Water Drainage

Onto 100 St. Paul Street Condominium

Structural Investigation Report

Property Address: 100 St. Paul Street, Brookline MA, 02446

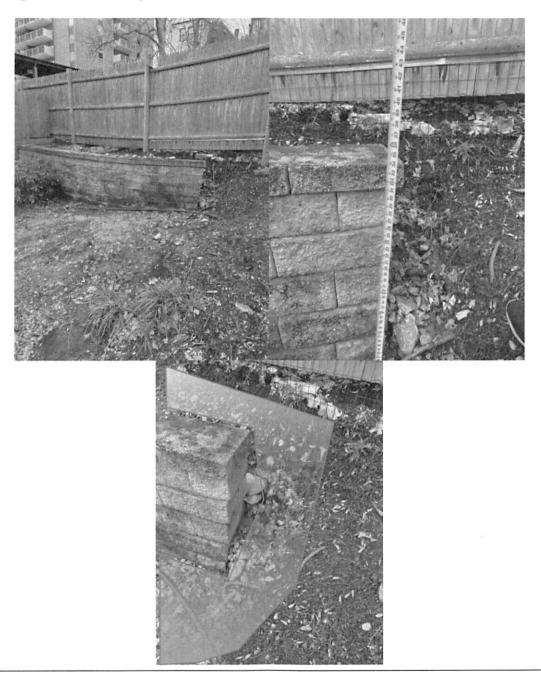
The right neighbor at 108, 114, and 118 St. Paul St. condominium residential buildings has over 8,500 sqft of paved parking lot without a drainage system. The pavement sloped toward the 100 St. Paul St. backyard. A significant amount of runoff water flowing under the fence at the corner of the property lot has eroded the backyard landscaping and deteriorated the existing 3-foot-tall retaining wall and wooden posts.

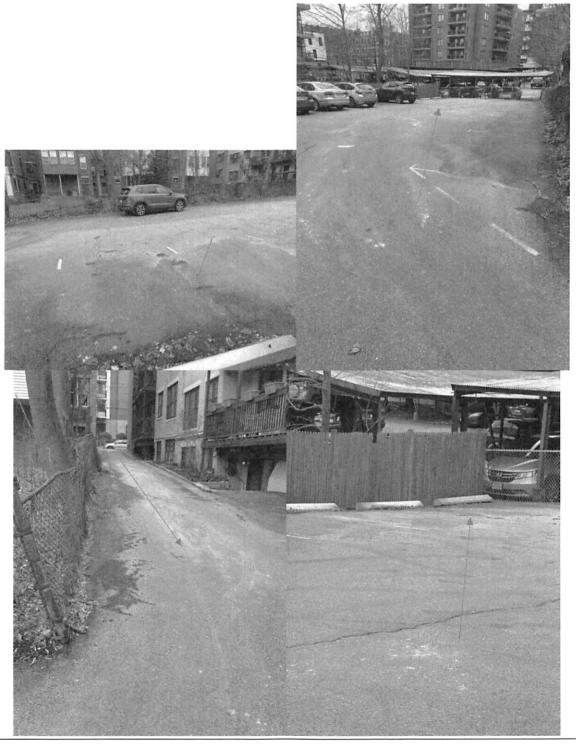
Considering the impervious area of the right neighbor, complete stormwater calculations design and runoff analysis of the impervious surface are required to comply with the Town of Brookline Stormwater management requirements.

The damaged and polluted backyard area by runoff water and the suspended solids discharged from the neighbor's property was observed during the site visit. Proper media filters need to be installed on neighbor's side to collect and remove the TSS.
